This page lists the know errors on the gm5x5x5 PCBs. There are no known issues with the bulk order run (white pcbs), the following information is valid **only** for the prototype run (green pcbs).

Bulk Order #1

#1 Silkscreen error

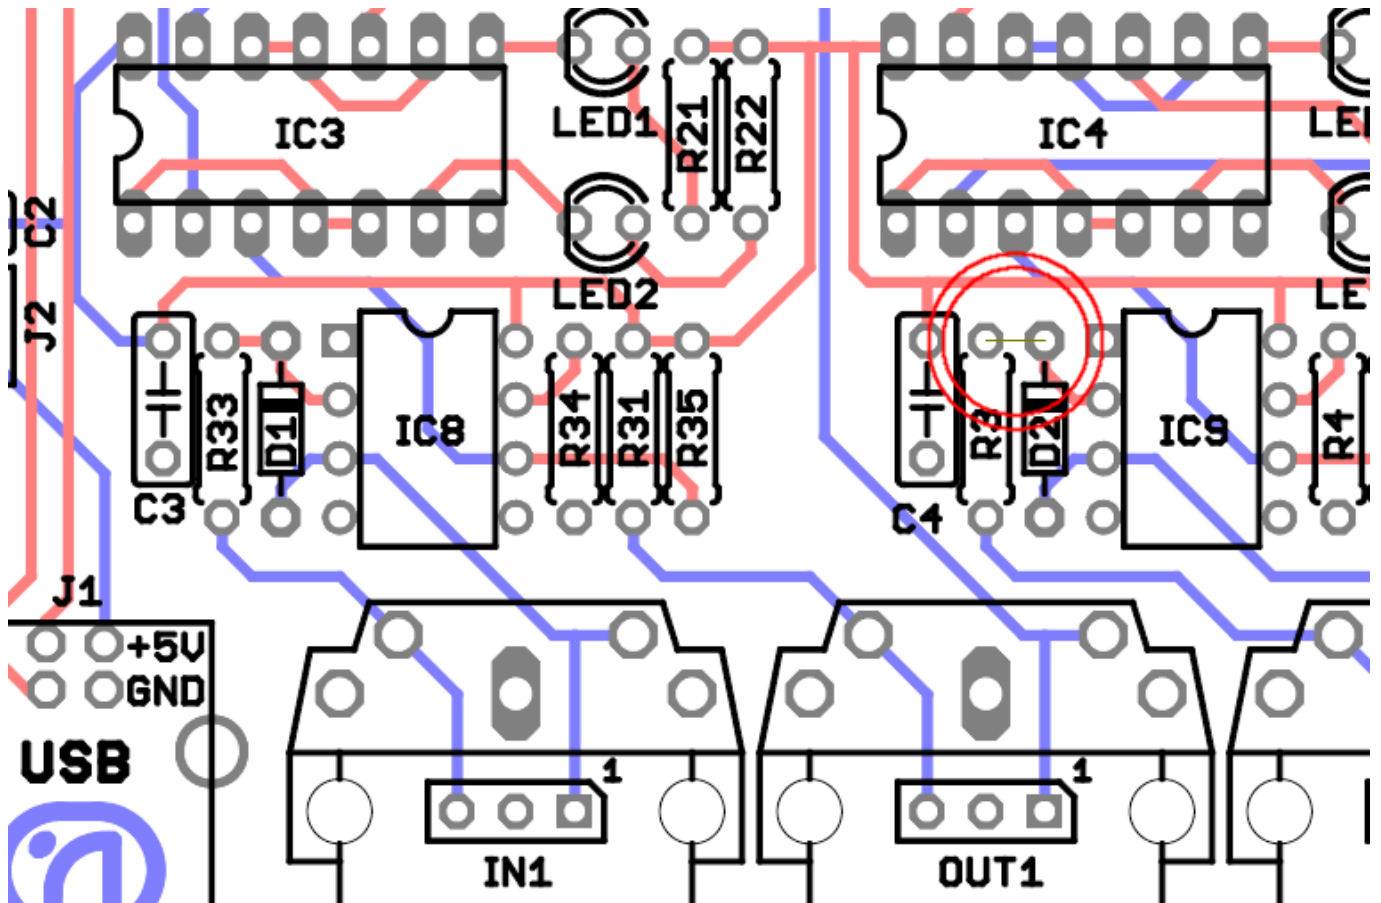
Problem: The silkscreen has the EEPROM the wrong way around - Pin 1 should be facing IC5.

Solution: Stick the EEPROM in the other way around, with the “notch” facing IC5.
